## DESCRIPTIVE REPORT

Williamson & Associates, Inc. conducted a hydrographic survey in the southern portions of Penobscot Bay, ME. The sub-locality of this survey is described as southern Penobscot Bay (Fig. 1). The survey encompassed an area of approximately 26.5 square nautical miles and was assigned registry number H12256. It is bound by the coordinates listed in Table 1. Project instructions required complete MBES in areas greater than 6 meters. The depth range encountered in this area was 6.4 to 117.7 meters. Total main-scheme nautical line mileage is 762.078. Total cross-line length surveyed for task order OPR-A366-KR-10 was 36.959 nautical miles or 4.85 percent of the total main scheme nautical miles. Data acquisition was conducted from the 26<sup>th</sup> of August (Julian Day 238) to the 28<sup>th</sup> of September (Julian Day 271) 2010.

REGISTRY NUMBER H12256

**Figure 8: Junken Ledge Chartlet**

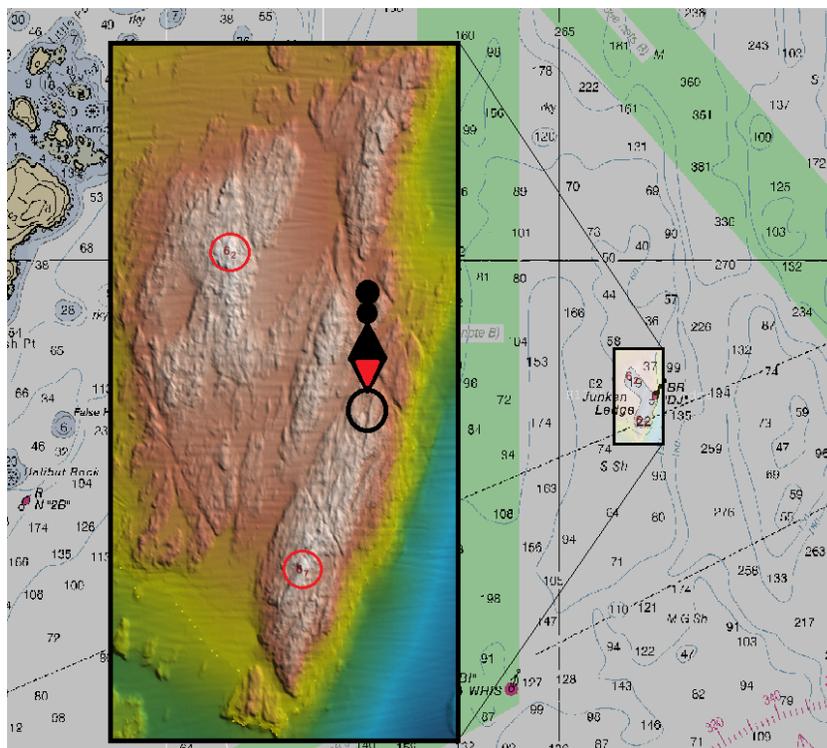
Junken Ledge located at 500704.96 (m), 4870868.35 (m) or 43-59-26.20N, 068-59-29.19W is charted correctly. As seen in the chartlet below there are two peaks of the shoal, the northern one with a least depth of 6.2m and the southern one with a least depth of 6.7m depth. The marker for the shoal is between these peaks however the depths in this area are charted correctly. This shoal was gridded down to 0.5m resolution and procedures followed that of Object Detections.

*Concur.*

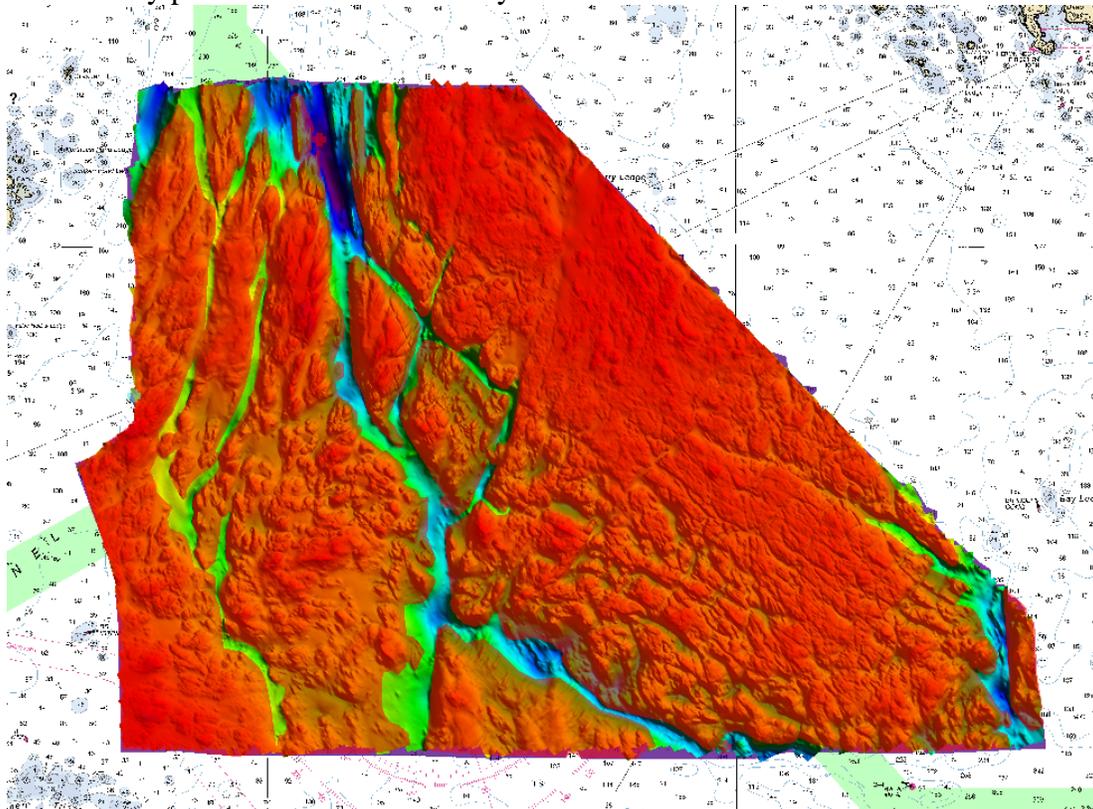
The charted hydrography originates with prior surveys and requires no further consideration. The hydrographer makes adequate chart comparisons in section D and Appendix I and II of the DR. The hydrographer recommends that any charted features not specifically addressed either in the HCell files or the Blue Notes should be retained as charted. The following exceptions are noted:

- a. Seven rocky seabed areas (SBDARE) were included with the HCell. These areas are defined by prominent rocks and rocky seabed.

- b. All currently charted “rky” seabed characteristics are being superseded by revised rocky SBDARE area features. Since bottom samples were not acquired for this survey all seabed characteristics other than “rky” are being retained as charted in the HCell.
